**Re: Supplement IV in Response to Data Requests and Workshop Queries in Support of the Application for Certification for the Sun Valley Energy Project (05-AFC-03)**

**Supplement IV in Response to  
Data Requests and Workshop Queries**

**Sun Valley Energy Project**

(05-AFC-03)

**FIGURE WSQ-8  
VALLEY SUBSTATION  
TIE-IN OPTIONS**

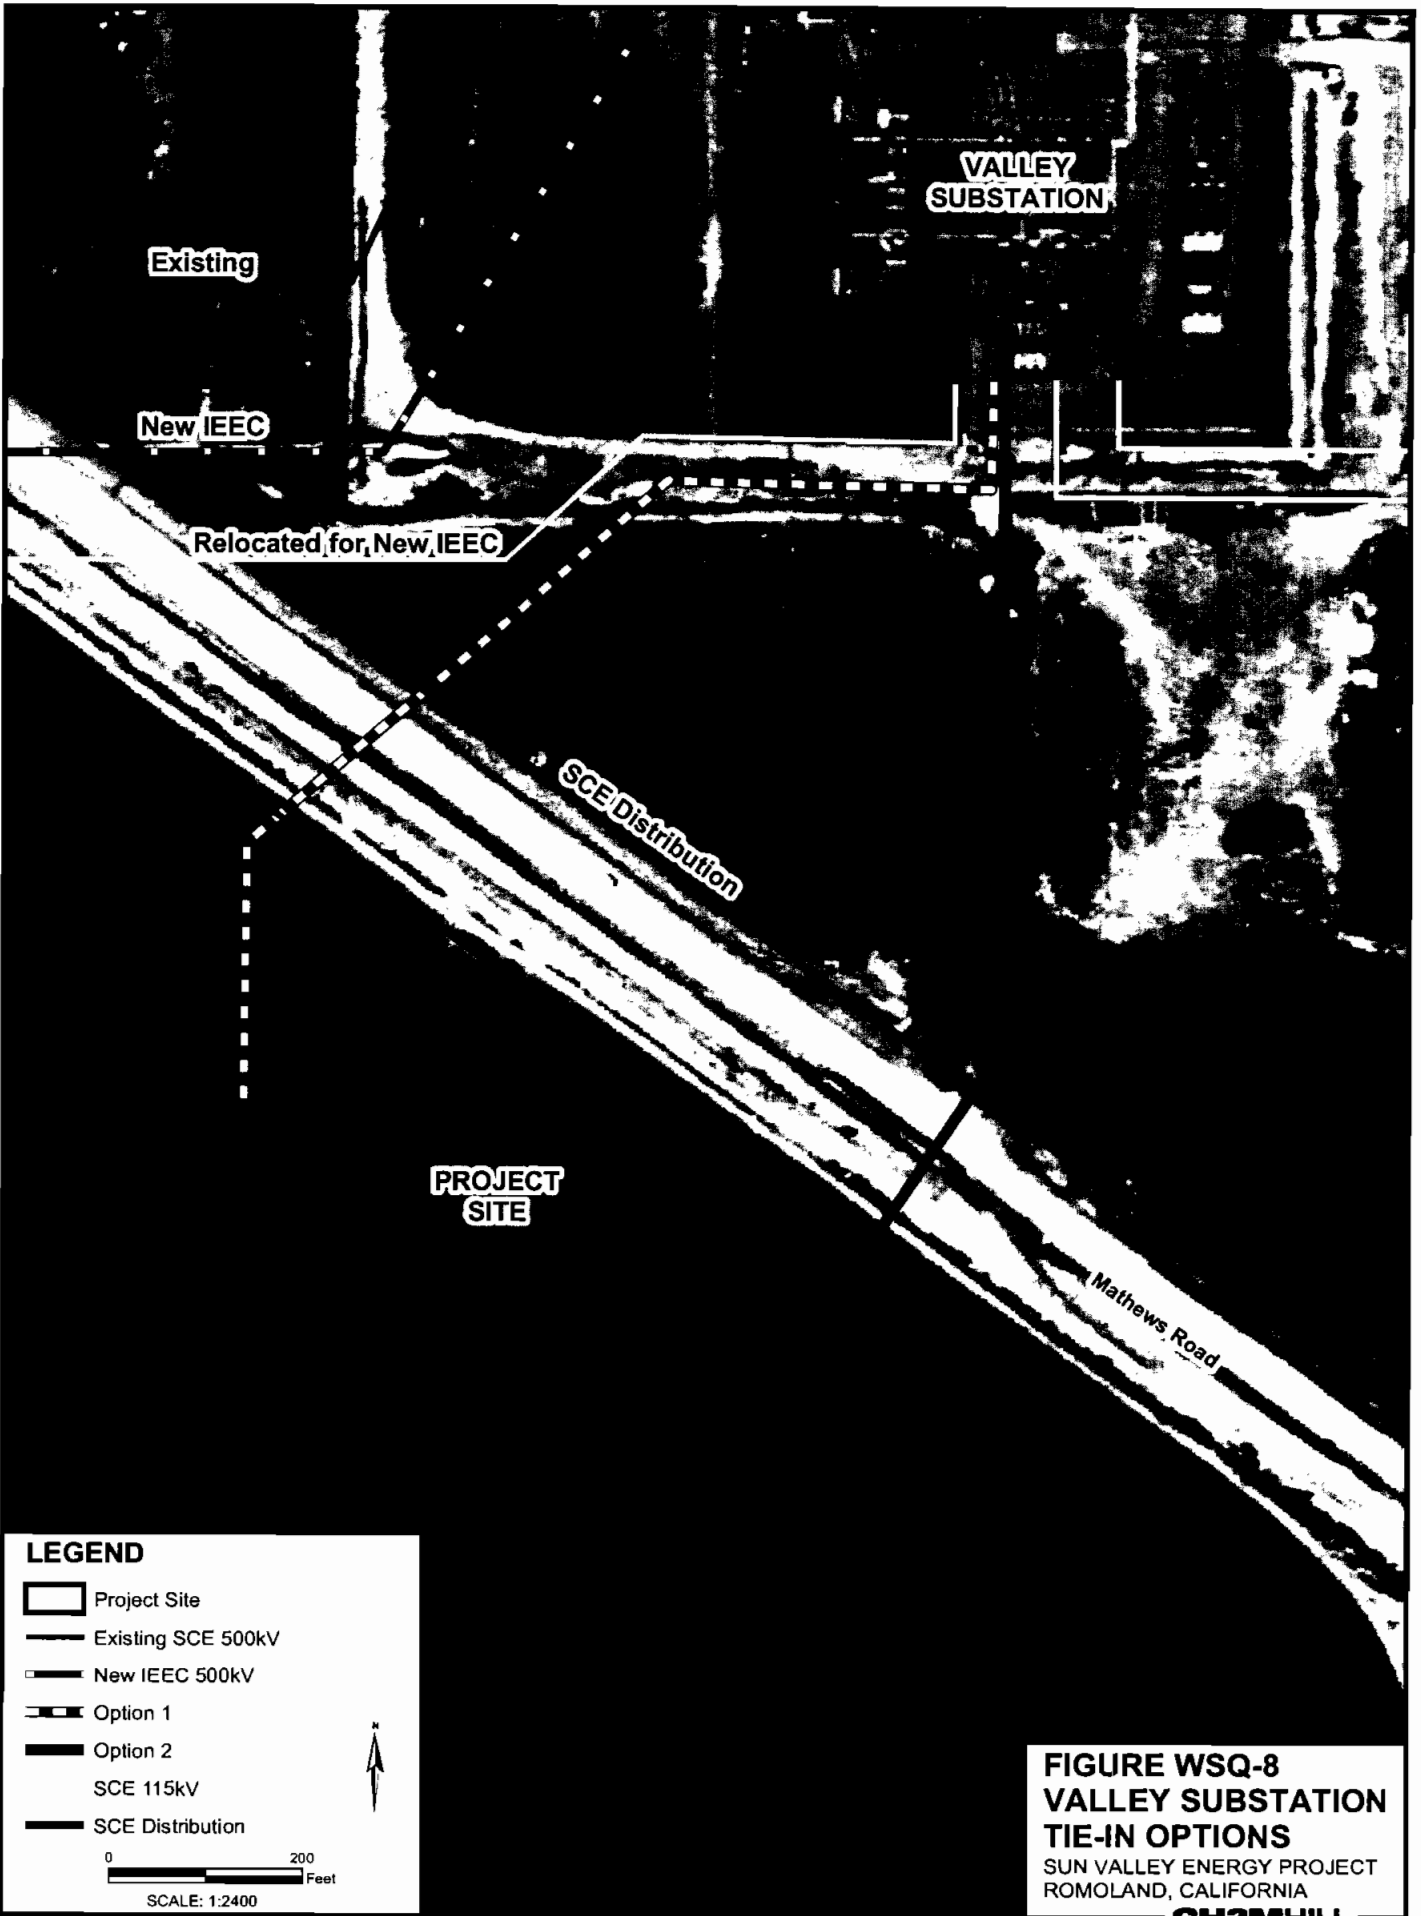
*WSQ-8 Has Southern California Edison clarified their role in developing a finalized routing for the generation tie line between the SVEP and the Valley Substation? If so, please provide this information.*

**Response:** During further discussions with Southern California Edison (SCE) in connection with SCE's interconnection study process, SCE has identified two generation tie-line options in addition to the project design option as described in the Application for Certification. These options are shown in Attachment TSE-1, Figure WSQ-8. One of these options, called Option 1, is very similar to the project design tie-line as described in the AFC and depicted in AFC Figure 5.1-1. In this design configuration, the tie-line extends from the northernmost corner of the SVEP parcel in a northeasterly direction, connecting to the southwest corner of the SCE Valley Substation. Option 1 uses this same routing, and takes into consideration the planned relocation of an SCE 115 kV transmission line that runs along the northern side of McLaughlin Road and connects to the Valley Substation from the west. This existing line will be relocated to accommodate a new 500 kV generation tie-line being constructed for the Inland Empire Energy Center. This relocated 115 kV line will run along the southern boundary of the Valley Substation, to connect with the substation's 115 kV bus. Option 1 would run parallel with and south of this relocated line, and would connect with the substation in the approximate center of the substation's southern boundary. This line would be approximately 900 feet in length (distance outside of the SVEP property boundary).

Generation tie-line Option 2 identified in Figure WSQ-8 would route the tie-line southeast within the SVEP property boundary and along the SVEP's northern boundary to a point just east of the SVEP's eastern boundary. From there, the tie-line would extend to the northeast across the Burlington Northern Santa Fe (BNSF) railroad and Matthews Road. On the northeast side of Matthews Road, the tie-line would angle slightly, turning due north to the Valley Substation, to a connecting point in the center of the substation's southern boundary (same as Option 1). The portion of Option 2 that would be located outside of SVEP's property boundary would be about 950 feet in length.

Although Figure WSQ-8 does not indicate the precise locations of transmission towers, it is likely that towers would be placed on either side of the BNSF/Matthews Road corridor. Option 1 would require turning towers at the southeast corner of the Valley Substation and at the substation center, where the line would turn north to enter the substation. Option 2 would require turning towers on either side of the BNSF/Matthews Road corridor and a tower at the substation and may also require an intermediate tower between the BNSF/Matthews Road corridor and the substation.

It is our understanding currently that VSE would be responsible for the generation tie connection as far as the first tower to the east of Matthews Road and that SCE would construct and own the tie-line on SCE property from that point to the Valley Substation. The final choice of generation tie-line route will be made by SCE.

In terms of environmental effects, Option 1 is nearly identical to the existing project design. The only significant difference is that Option 1 would include the turn to the east, paralleling the relocated 115 kV line from McLaughlin Road, and one or two additional towers. The additional towers would be located on SCE property at the perimeter of the substation. The additional towers would have a negligible effect, from a visual resources point of view, because the substation area is already congested with towers and transmission lines and because the new towers would not block a scenic or protected viewshed.

Option 1 is within the area surveyed for biological and cultural resources. Portions of Option 2 were not surveyed for cultural resources, but potential impacts would be limited to the two or three (maximum) tower locations if cultural resources were present. The biological reconnaissance included the Option 2 route. Neither option would cause impacts to wetlands or endangered species.

November 2002 - October 2003 Electrical Demand vs Weather Data for Riverside, CA

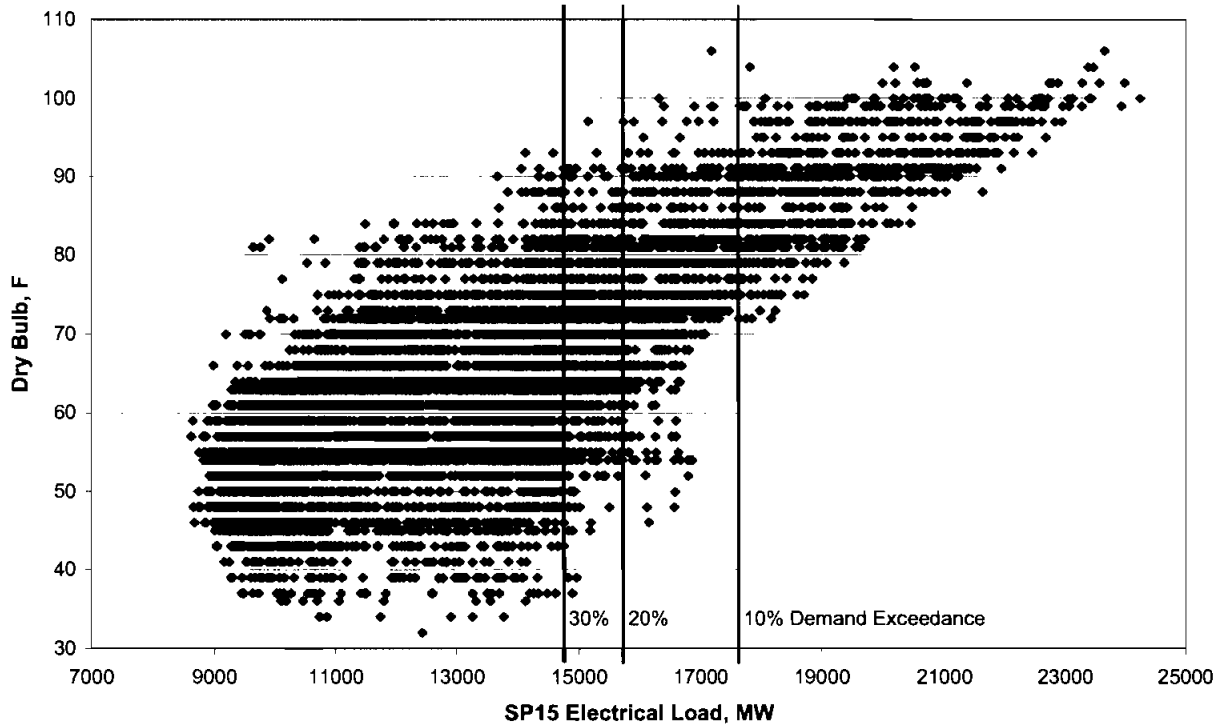
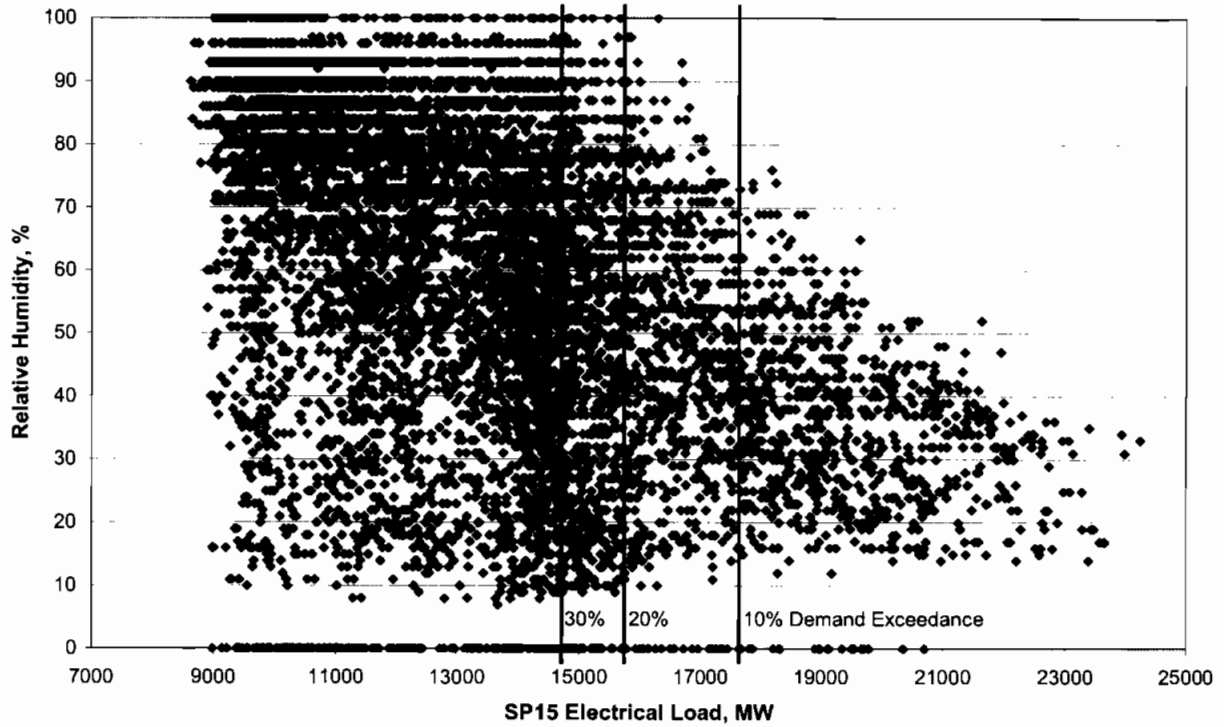
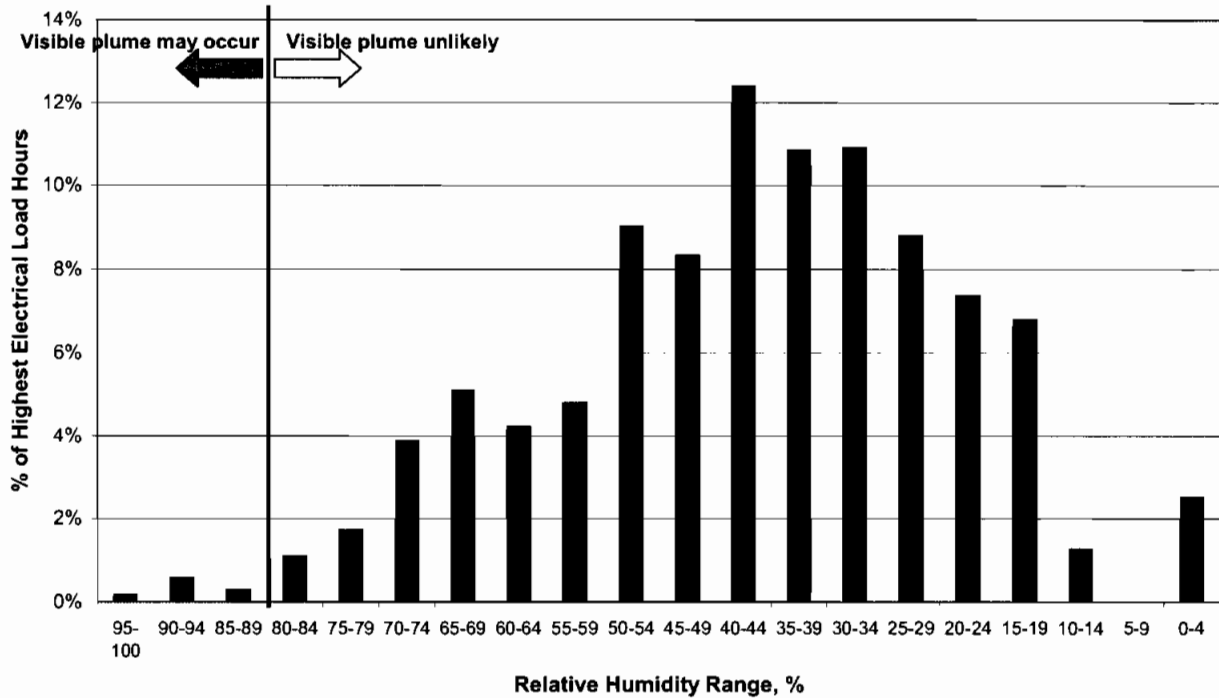
DR67. *If the applicant performed a visible plume modeling analysis in support of the AFC Visual Resources conclusion, please provide the modeling results, any meteorological data used in the analysis, a full discussion of all assumptions, the name and version of the model used, and all model input and output files. If a modeling analysis was not performed, please provide any analysis that supports the visible water vapor plume discussion in the AFC.*

The SACTI model was modified to produce an output listing of the meteorological conditions that produced a visible plume. The SACTI cooling tower plume modeling output shows that a visible plume generally only occurs when relative humidity exceeds 85%. In order to evaluate the likelihood of this atmospheric condition coinciding with plant operation, hourly electric load data from the California ISO for the SP15 zone (effectively SCE's and SDG&E's service area) for the period of November 2002 through October 2003 was obtained, and hourly weather data for Riverside, CA for the same period was obtained. As one would expect, regional electrical loads are highest when dry bulb temperatures are highest due to air-conditioner use on hot summer days, as illustrated in the chart below.

The vertical red lines indicate the SP15 electrical loads that are exceeded 10%, 20% and 30% of the time (i.e., 10%, 20% and 30% of the data points are to the right of the respective lines). Although a peaking powerplant may occasionally be called on to run to alleviate a power grid emergency or unexpected outage of a baseload powerplant, almost all operation of peaking powerplants will be during the highest electrical loads.

On hot summer days, as dry bulb temperatures (and corresponding electrical loads) increase to afternoon peaks, relative humidity naturally decreases due to the increased moisture-holding ability of the warmer air. It would be expected, then, that high electrical loads would correlate negatively with high relative humidity. The chart below is a plot of the same electrical loads as those in the preceding chart, but versus the relative humidity prevailing at the time of those loads, and illustrates the expected negative correlation.

The chart below is a frequency distribution of the relative humidity during the hours corresponding to the highest 20% of electrical loads. Relative humidity only exceeds the 85% level at which visible plume may occur during 1.0% of the hours in which the highest 20% of electrical loads occurred during the one year period for which data was obtained. Expressed as a percent of the entire year, 1.0% of 20% of the year is an incidence of less than 0.2%.
